Product Change Notification: P-25-029513

4POS,MATE-AX,SOC HSG ASSY.180DEG

The part revision will be changed from revision C to revision D, the assembly part numbers remain the same

1.)

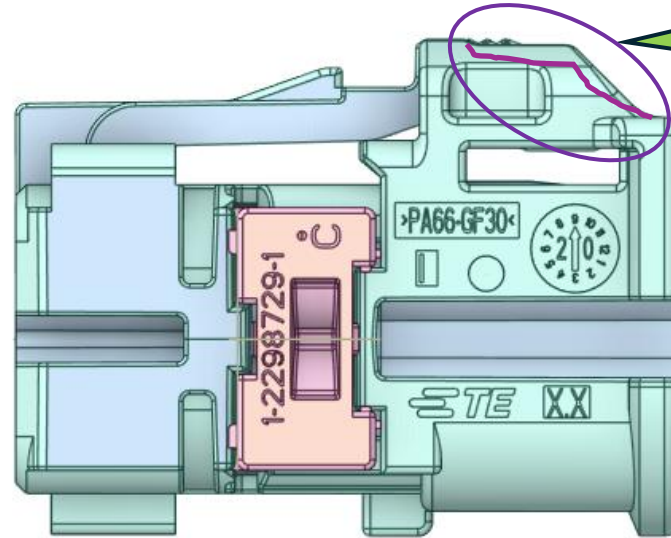
Locking Latch optimized, to avoid breakich latch during mounting process in the car

2.)

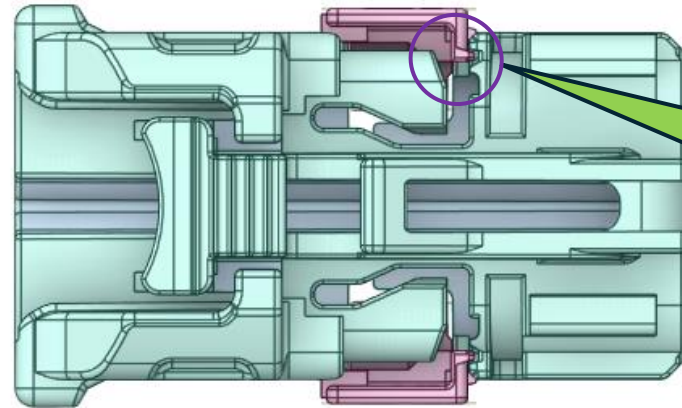
TPA optimized, to avoid loosing TPA in shipping process
